## Chevy Chase Lake Block B: Preliminary Plan Amendment 12002020B and Site Plan 820160190

Staff Report Date: 05/12/2017

### **Preliminary Plan Amendment No. 12002020B**

#### **Site Plan No. 820160190**

Applicant's Soil Volume Exhibit (in green)

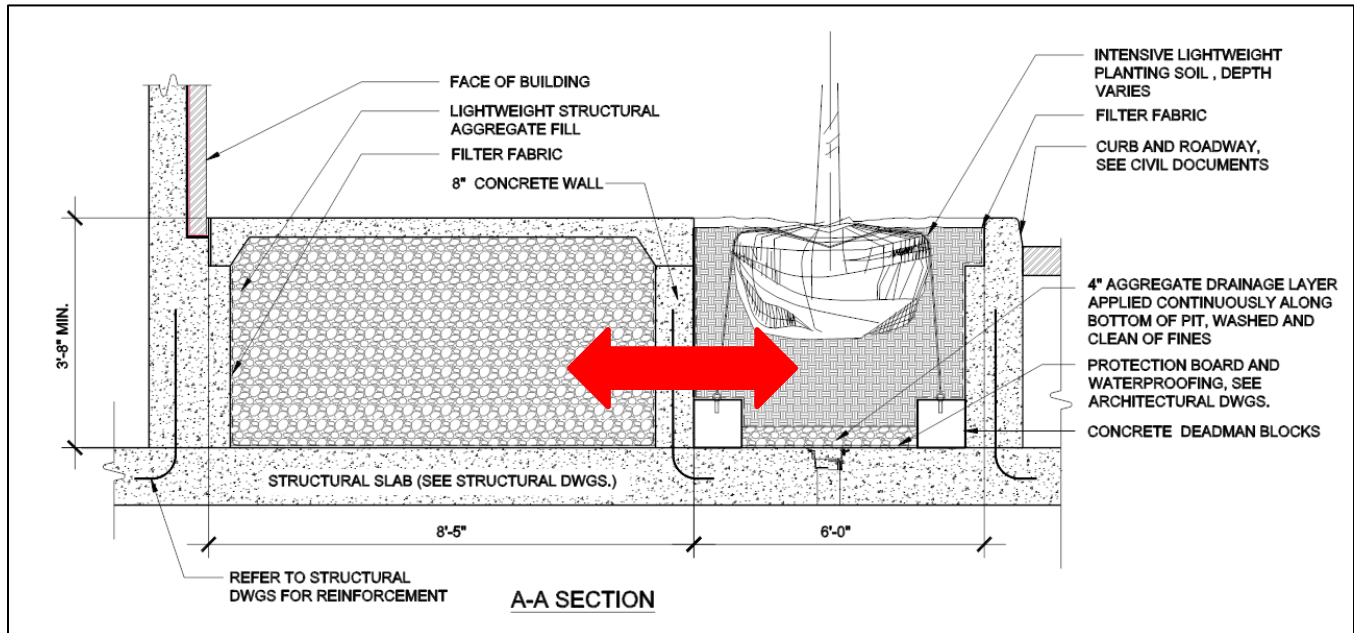
The drawings, as submitted, do not meet this condition or the tree canopy goals of the Sector Plan. The applicant is proposing only about 500 cubic feet of soil per tree. This soil volume is insufficient to support the long-term growth and health of the trees in this new development and will result in stunted trees. In acknowledgement of this built-in limitation on the potential growth of these canopy trees, the applicant's canopy measurements submitted in the canopy exhibit were specifically reduced by 75%.

However, the design of this application, wherein the entirety of the on-site public realm is built over structure, provides a ready-made stratum of space above that structure that must be filled to support the site elements above: road, sidewalk, park, and trees. Staff is recommending a condition of approval that the applicant design the fill of the spaces not used for vehicular access to accommodate root growth for the trees on-site.

Whereas the applicant's current soil volume design (shown above) only allows the trees to grow within a small portion of the public realm, primarily in line with the amended soil panels, the recommended condition allows the tree roots to extend under the sidewalks and the "Town Square" open space, as shown below. The

- a. Prior to certification of the Site Plan, the Applicant must modify the tree planting details shown on the Site Plan to allow roots to extend under sidewalks and adjacent public open space areas, excluding areas for motor vehicle circulation.

*Construction detail from the Site Plan Soil Volume Detail sheet (L4.03). Red arrow, added by staff, indicates opportunity to connect and significantly expand the soil volumes available for tree plantings.*

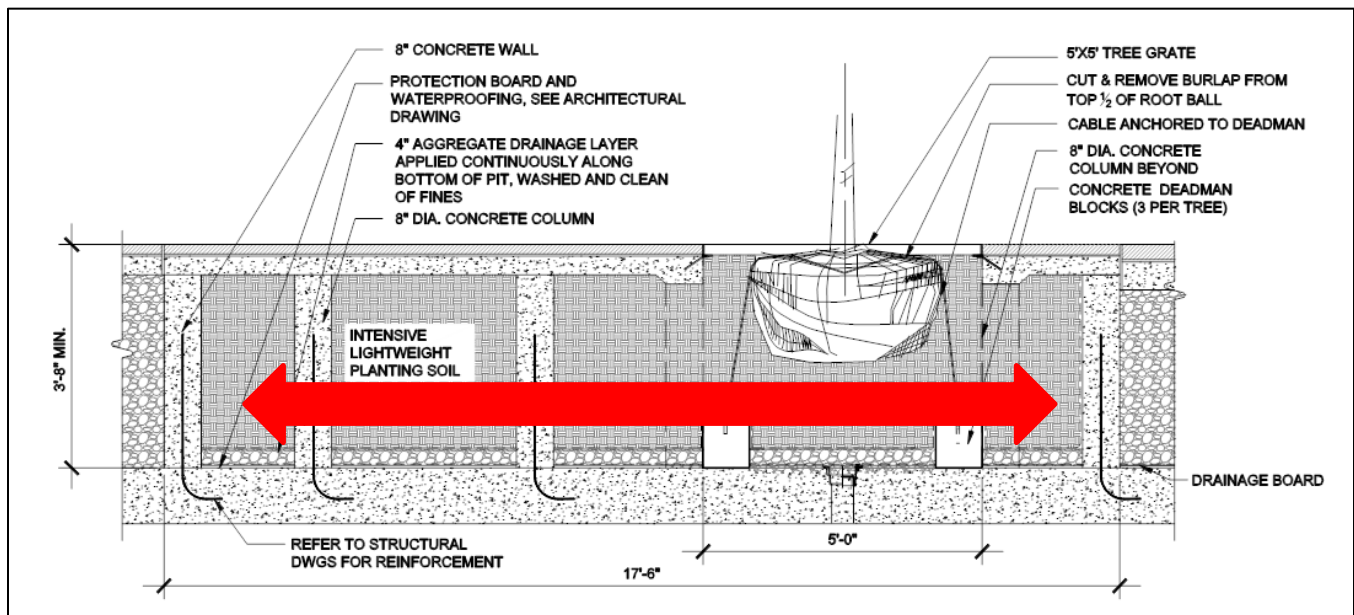
applicant is using a similar detail along the north side of the Town Square. This begins to take best advantage of an existing site design feature, and the recommended condition will expand its reach.

*Tree root expansion area detail (red arrow by staff)*
